ADDENDUM #2

August 20, 2010

Re: Harrisburg Area Community College
Central Administration – Phase 2 at Penn Center
Solicitation # 11-06

From: Eastern PCM, LLC
Construction Manager – HACC
645 N. 12th Street, Suite 200
Lemoyne, PA 17043

Description
STRUCTURAL PLANS

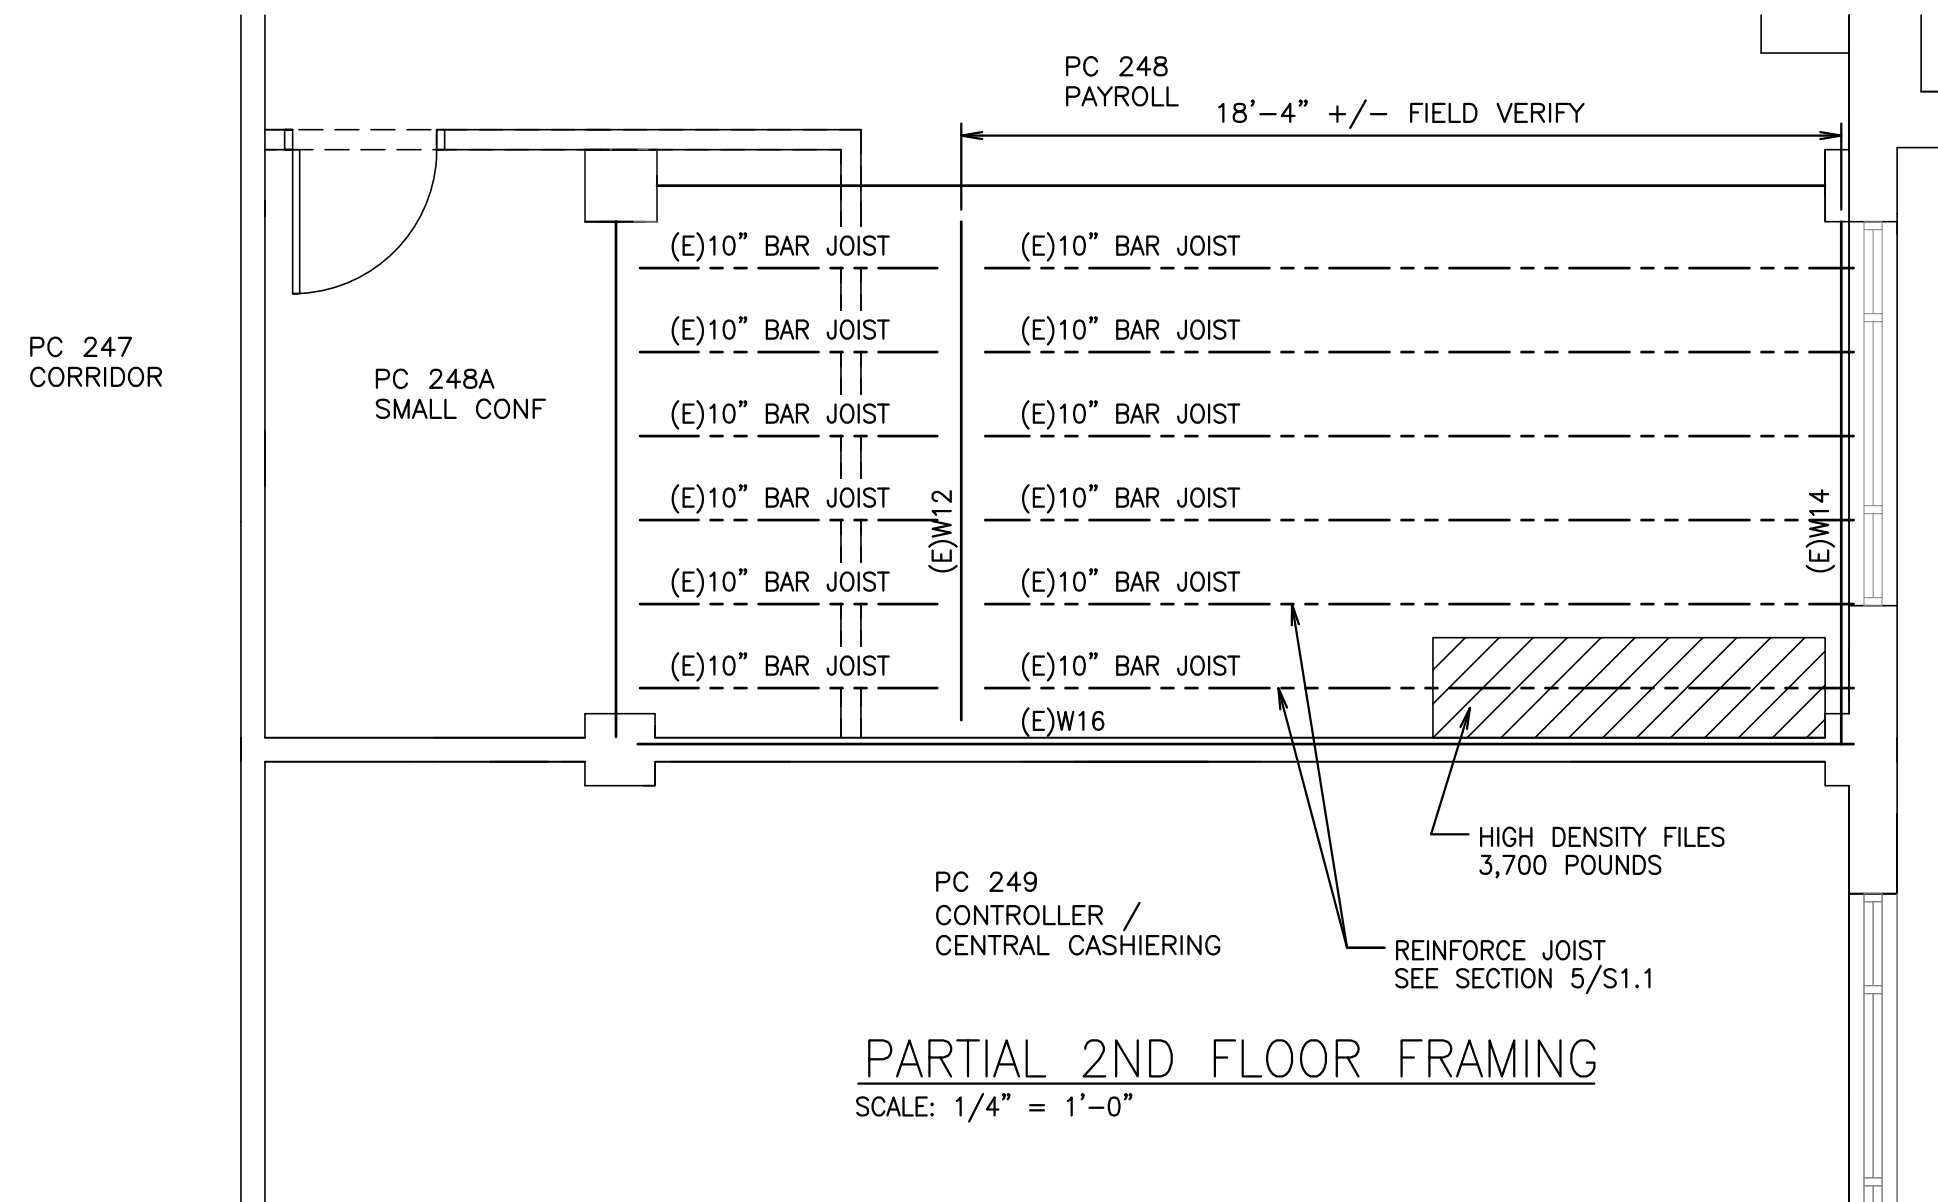
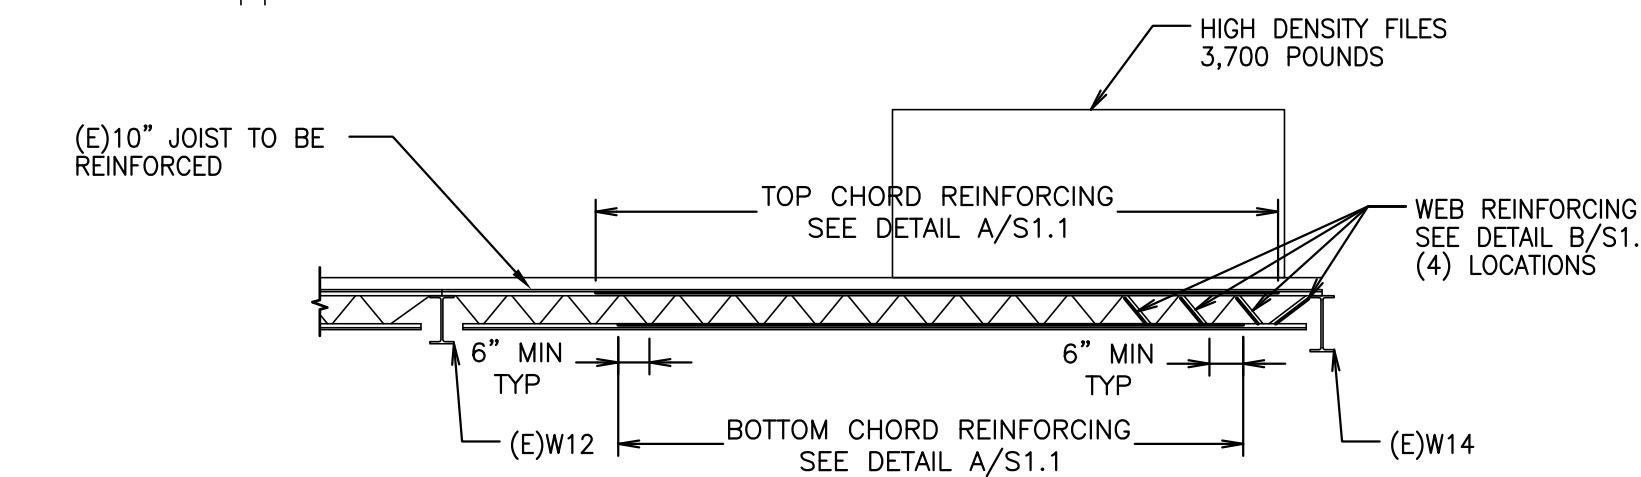
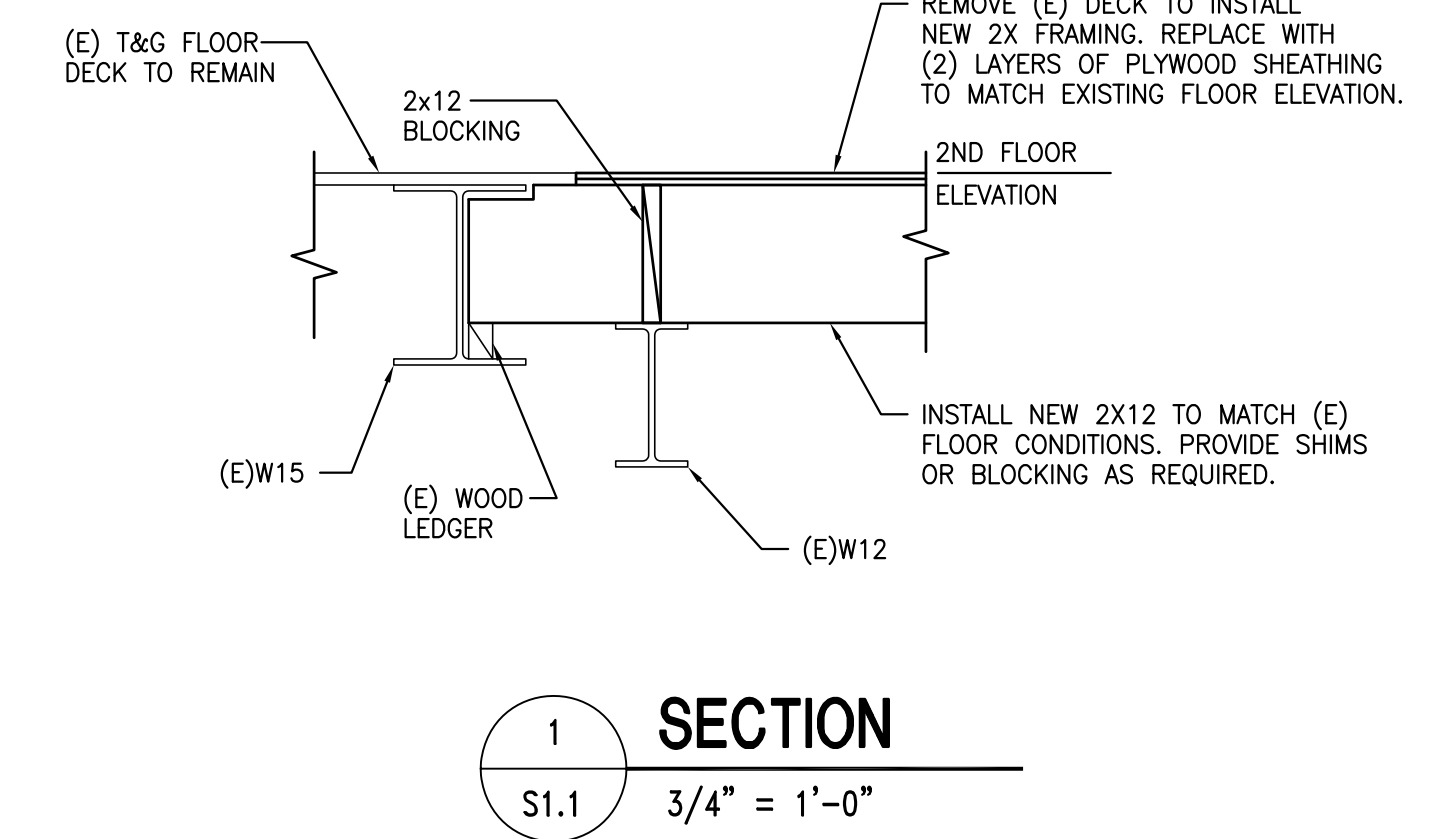
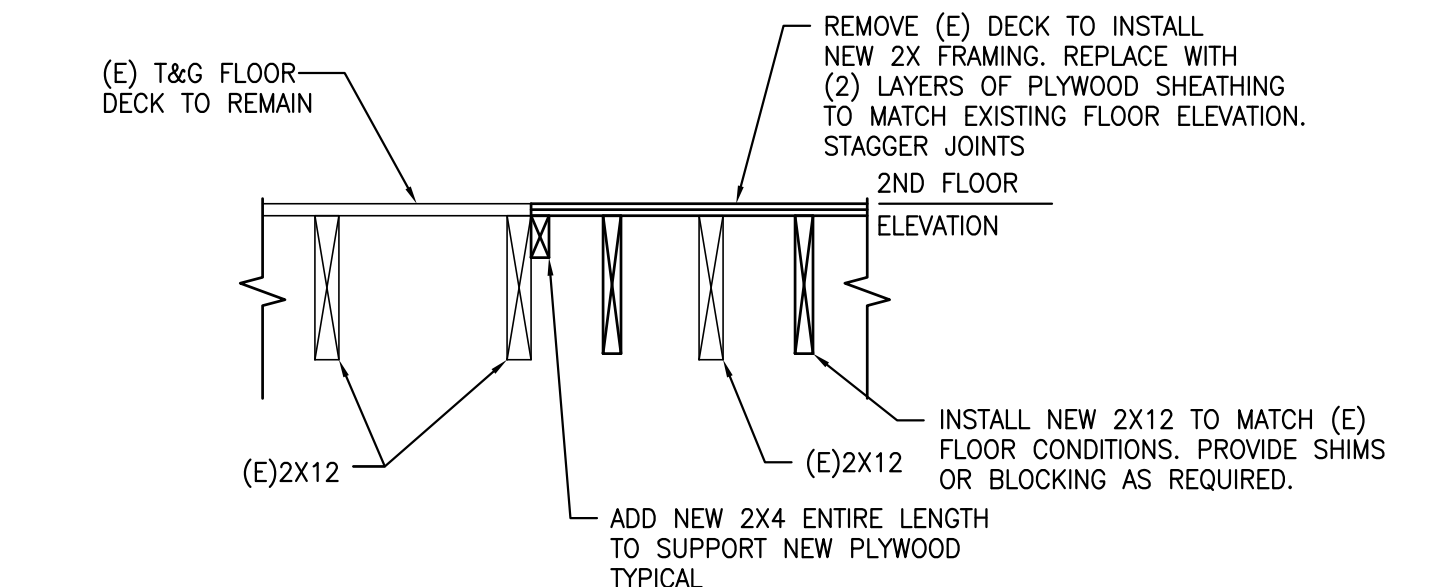
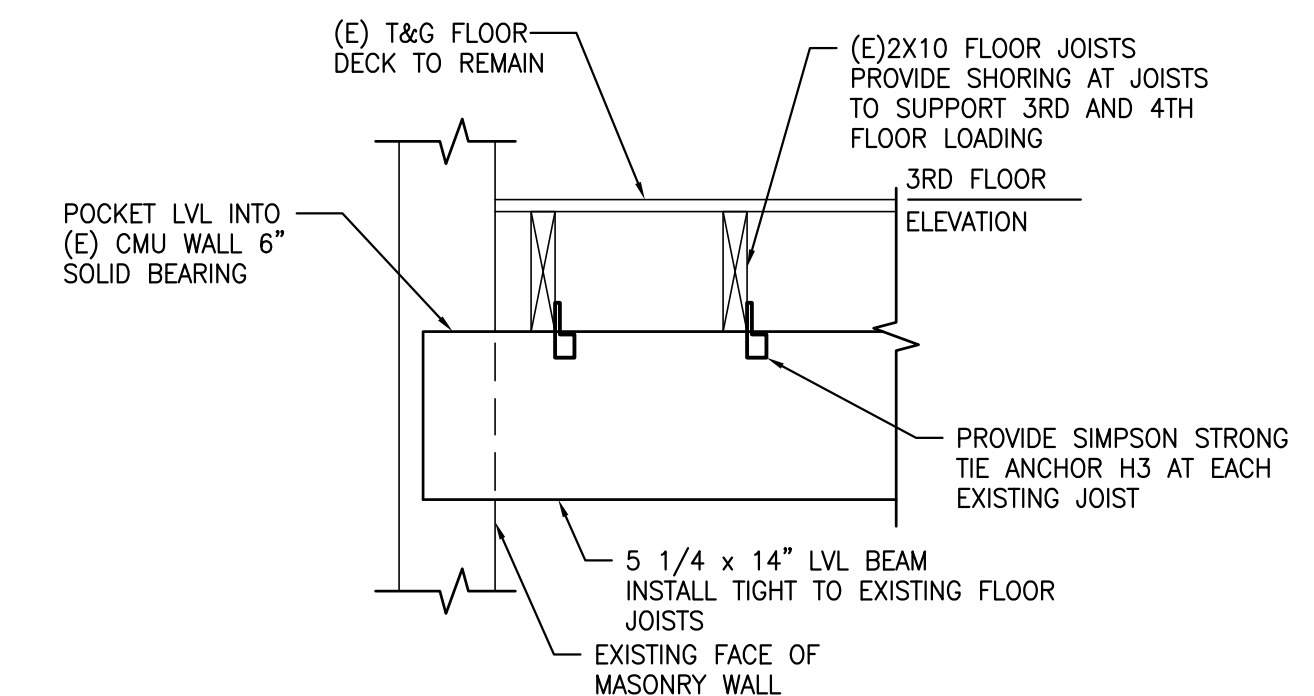
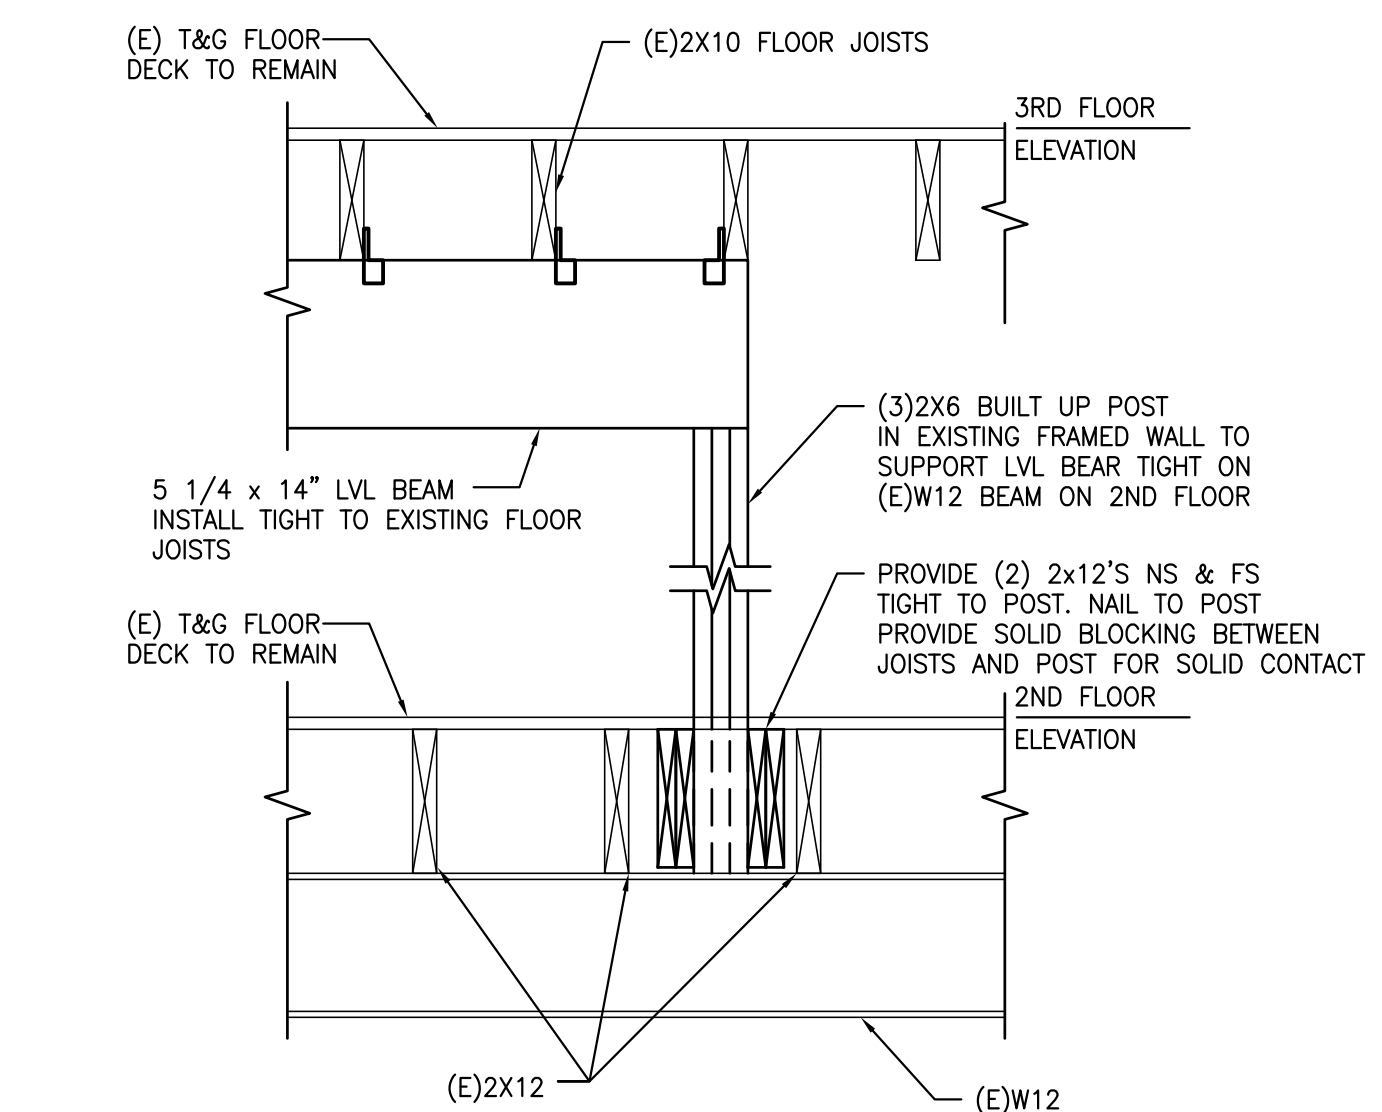
ADD iv. Structural modifications will be required for addition support. See attached drawings.

1. M-1 Second Floor Mechanical
2. M-2 Third Floor Mechanical
3. S1.1 Structural Plans
